Re. DA2023/1395 (1010, 1012 & 1014 Pittwater Road, Collaroy NSW 2097)

Opening remarks

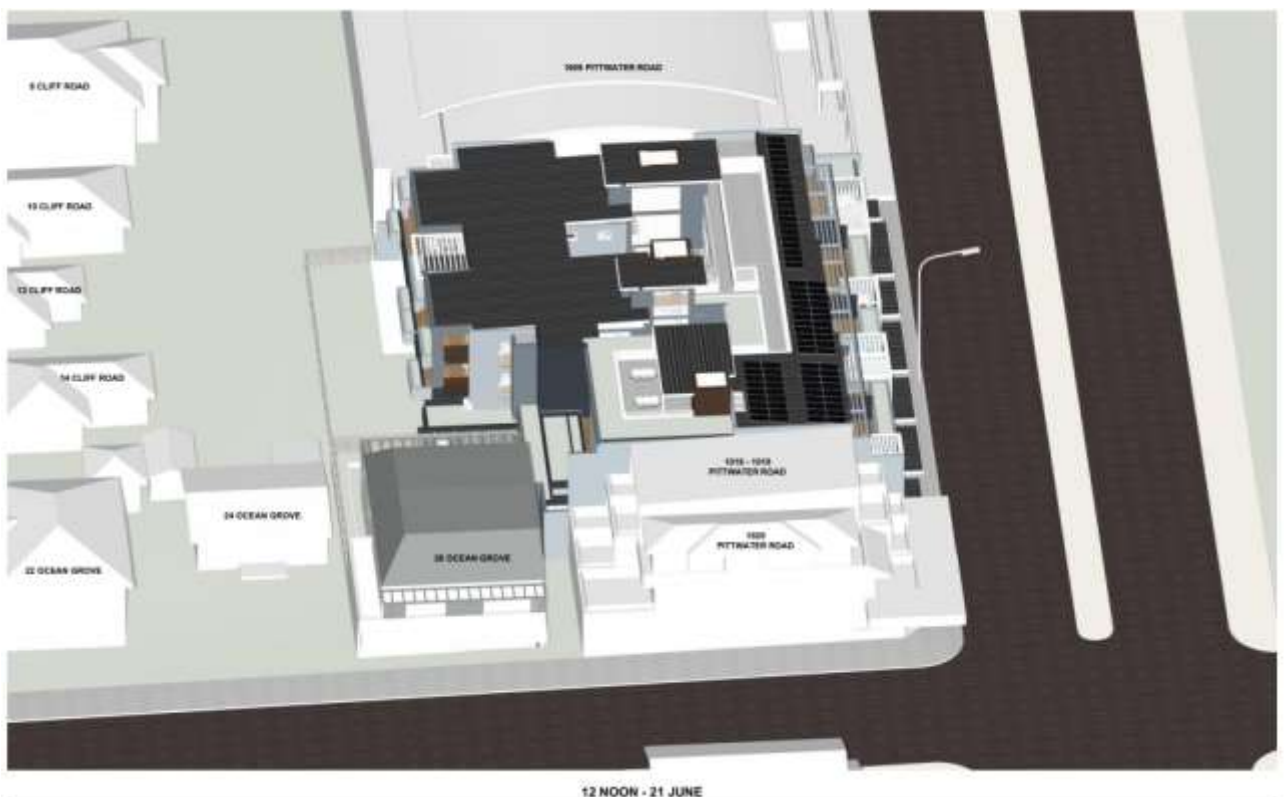
3. The Amended Plan, where it concerns the rear boundary of 1014 Pittwater Road ("hereby referred to as the "rear boundary") towards my residence, now includes a small 'carve out' setback measuring one metre in distance. The planning instruments require a minimum six metre rear boundary setback. The proposed setback is illustrated in Figure 1 below; reproduced as a copy from page two of the applicant's solar access plans that were submitted on 20 November 2024. This setback is considered inadequate where it concerns access to light, for the following reasons:

- 3.1 A one metre rear setback, combined with a zero-rear setback along the rest of the rear boundary at 1014 Pittwater Road, is not what is intended by the planning instruments. The regulations prescribe a six-metre rear setback applying to the entire length of the rear boundary.

- 3.2 Section 2H of the Apartment Design Guide ('ADG') provides that the proposed development *"provide access to light, air and outlook for neighbouring properties and future buildings."* As illustrated in Figure 1 above, proposing a narrow one metre 'well' will not provide any level of reasonable access to light to my property's window. Further, this proposal does not meet the objective found in Clause D6 of the Development Control Plan ('DCP'), being *"to ensure that reasonable access to sunlight is maintained."*
